Access Compliance Report

Public Rights-of-Way

(Pedestrian Signals)

Intersection ID: N/A	Main Street:	Cross Street: N/A	Location: N/A
ADA ID: 46DDEE1FD35A	Signal Type: One Push Button-Non APS	Overall Compliance: No	Severity Score: BTN 1: N/A BTN 2: N/A No BTN: N/A
Codes/Mitigation Info/Possible Solution		Field Measurements/Component Compliance

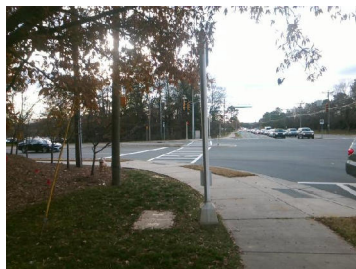
PROW/ADA: TMUTCD 4e.08, R404.2, R404.3

Yes	B 1 Clear Xing Direction?	ClearlyMarked	N/A	B 2 Clear Xing Direction?	N/A
	B 1 Crossing Direction	To SW		B 2 Crossing Direction	N/A
No	B 1 DistanceTo XWalk (in)	74.0	N/A	B 2 DistanceTo XWalk (in)	N/A
No	B 1 DistanceTo Curb (in)	136.0	N/A	B 2 DistanceTo Curb (in)	N/A
Yes	B 1 Diameter (in)	2.0	N/A	B 2 Diameter (in)	N/A

Possible Solutions: Replace Signal Push Button With APS Button on New Post. Remove & Relocate Sign.
